Wisconsin Department of Transportation

Proposal #22: 1570-05-63, WISC2021499
Turtle Lake - Cameron
CTH P to Wye Street
USH 8
Barron County

This is Addendum No. 01, which provides for the following:

ADDENDUM NO. 01

Addendum No. 01
ID 1570-05-63/73
Revised Sheet 12
September 8, 2021

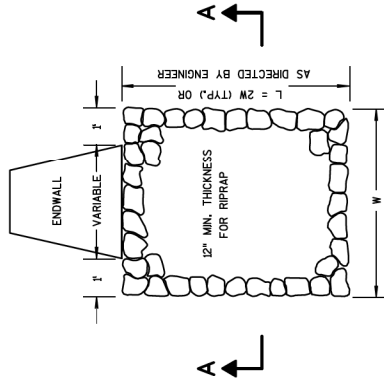
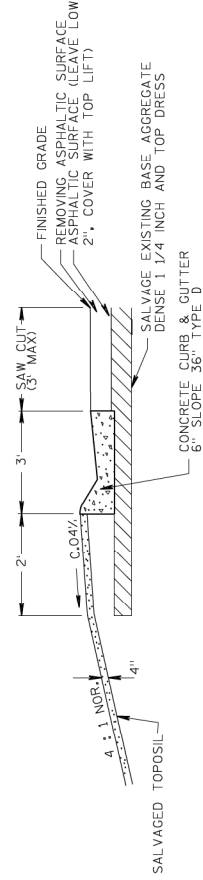
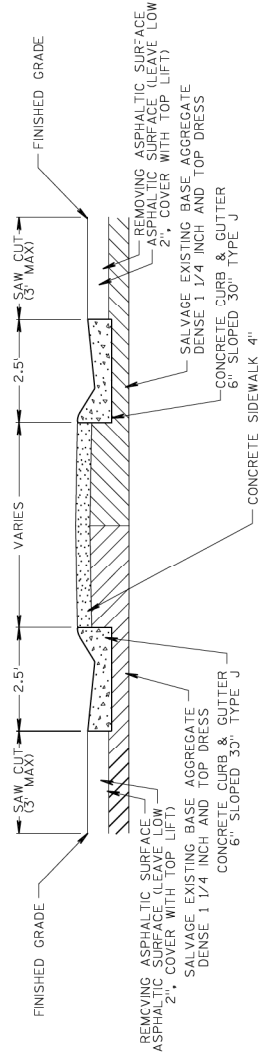
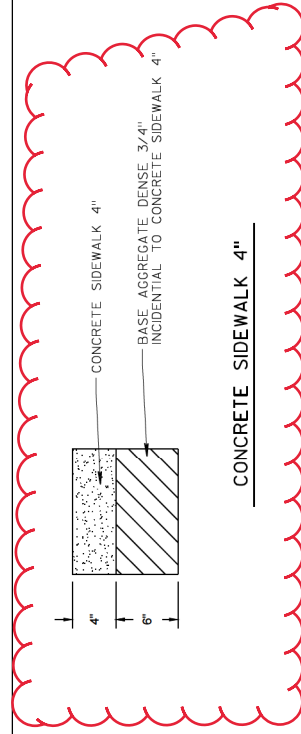
Revised Plan Sheets	
Plan Sheet	Plan Sheet Title (brief description of changes to sheet)
12	Construction Detail (Added 4" Concrete Sidewalk construction detail)
13	Construction Detail (Removed the mention of "Saw Cut Req'd")
22	Wall Modular Block Gravity Landscape (Modified retaining wall length)
30	Miscellaneous Quantities (Added quantity for items 602.0405 and SPV.0165.02)
37	Miscellaneous Quantities (Lowered 690.0150 and SPV.0165.01 quantity)

CONCRETE SIDEWALK 4"
